V2500-A5 SERIES SERIES PROPULSION SERVICE BULLETIN

This document transmits Revision 4 to Service Bulletin NV2500-71-0273

V2500-NAC-71-0273

NACELLE – ENGINE BUILD UNIT (EBU) – REPLACEMENT AND REROUTING OF SEVERAL EBU SYSTEMS
TO ACCOMMODATE THE REROUTING OF THE OIL SCAVENGE TUBES

Partial Installation of the Fire Detection Harness (System A)
 Figure 13, Sheet 1 of 3

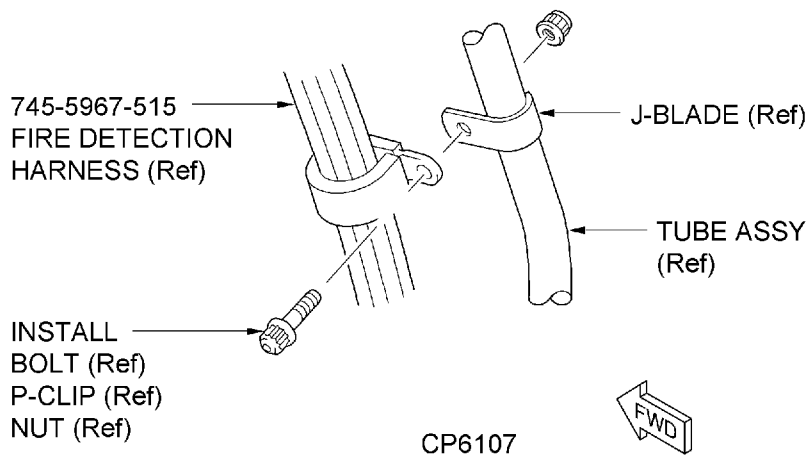
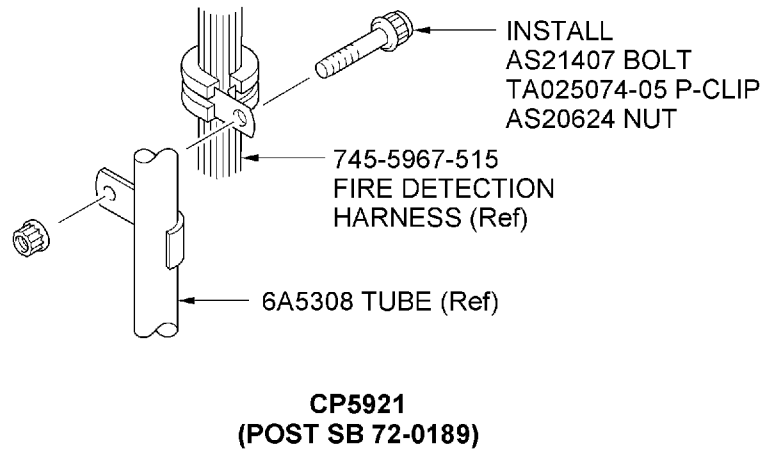
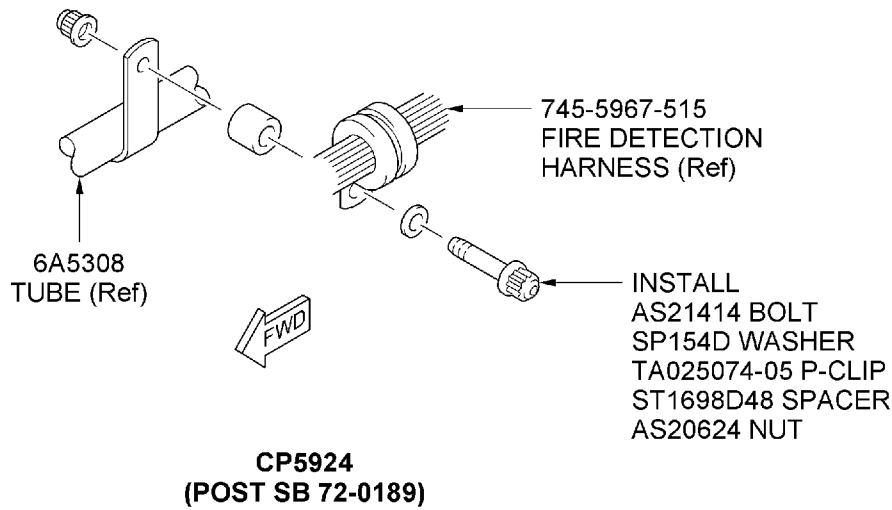
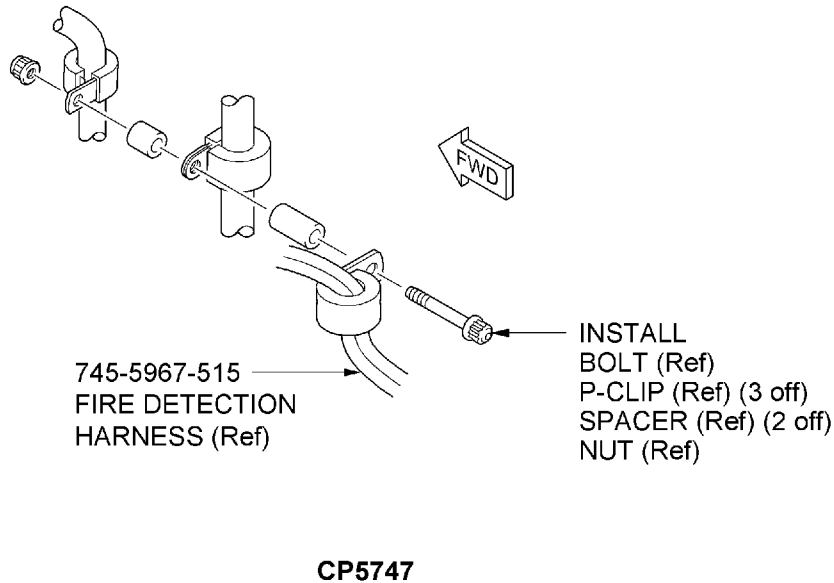
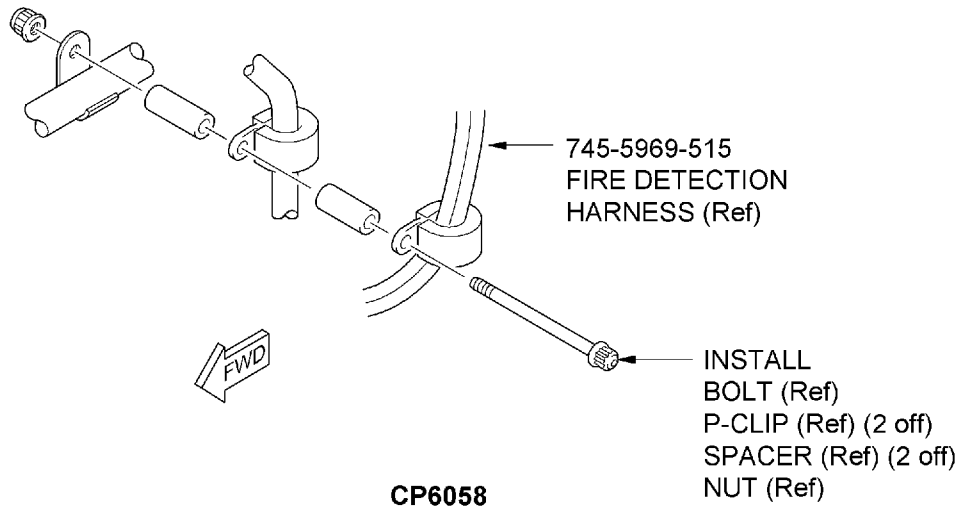
- (d) CP5990 - Attach the Harness to the Cabin Air Bracket with the TA025074-05 P-Clip, the TA025074-01 P-Clip, the AS21407 Bolt, the two SP154D Washers and the AS20624 Nut. Refer to Figure 13. Lubricate all Clipping Point Bolts and Nuts with Engine Oil CoMat 10-039 or CoMat 10-040.

- (f) CP6107 - Attach the Harness. Refer to Figure 13.
- (g) CP6058 - Attach the Harness.

| (d) CP5990 – Attach the harness to the Cabin Air Bracket with the TA025074-05 P-Clip, the TA025074-01 P-Clip, the AS21407 Bolt, the two SP154D Washers and the AS20624 Nut. | Refer to Figure 13.
| (j) CP6107 – Attach the Harness. | Refer to Figure 13. |
